Re: Reassessment (Class II permissive change)

Applicant: Abbott Medical Optics

FCC ID: VGESCP135T

Figure 1. Keypad supporting plate material change: Original remote (top) and modified remote (bottom).

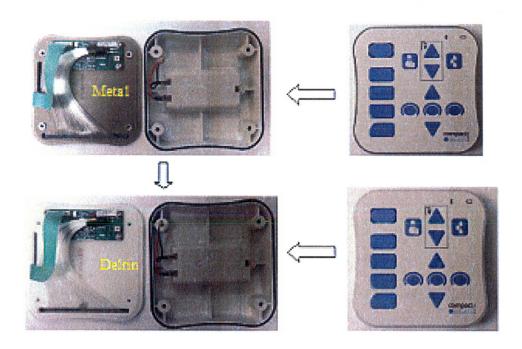
The reason we modify our device is to enhance the reliability of the wireless communication by changing the supporting keypad material from metal to Delrin, see figure 1. This change only affects the internal placement of the board. No change was made to the electronic circuit or RF circuit of the device. In other words, components, schematics and layout of the board remain unchanged. The radio frequency and intended functional capability of the device remain the same. Please see attached test reports for confirmation on the equivalent RF performance between these devices.
